CitiPower/Powercor Technical Standards Update for October 2019

DS501 – Standard Nomenclature for Equipment Nameplates

Standard EP Series – Voltage Regulators

ER – ACRs, FIs and Sectionalisers Key changes*

Figure 1 – REFCL neutral bus

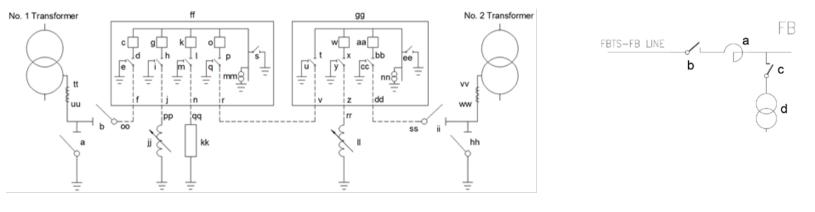
- Technical Standard DS501 has been updated to include signage for REFCL neutral bus and signage for 66kV reactor arrangements.
- Section 5 of the standard has been updated to include typical example layouts and their associated signage.

- As a part of the REFCL rollout, it's been identified that a standard naming convention for the neutral bus, associated switches, cables and instrument transformers needed to be developed.
- Another project also identified that there was a need for a worked example for labelling of 66kV reactors which is also included in this update.

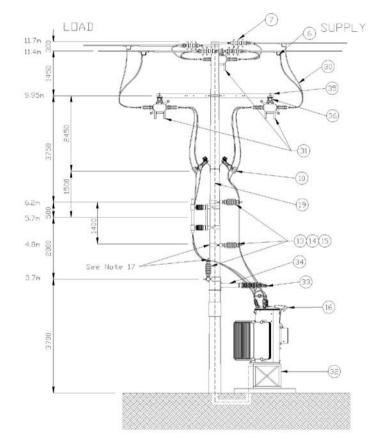
- Technical Standard EP102 has been updated to remove the pole mount regulator support platform and include the addition of a gas switch in place of an air break switch.
- Technical Standards EP105 and EP106 have been updated to include gas switches in place of air break switches. The concrete box culvert regulator supports have also been replaced with a steel frame support structure.
- Technical Standards EP103 and EP501 have been updated to become for maintenance only applications and not for new construction

- The main purpose of the standard update was for the replacement of air break switches with gas switches. Gas switches are more reliable and less prone to operational issues
- The concrete box culvert support have been replaced with steel frame supports to provide a more sturdier support structure for the regulators
- EP103 and EP501 are maintenance only due to mounting platform issues as a result of varying regulator designs over the years. It was decided amongst stakeholders that only 50A and 100A regulators will be mounted directly to the pole. 200A and 300A will now only be ground mounted.
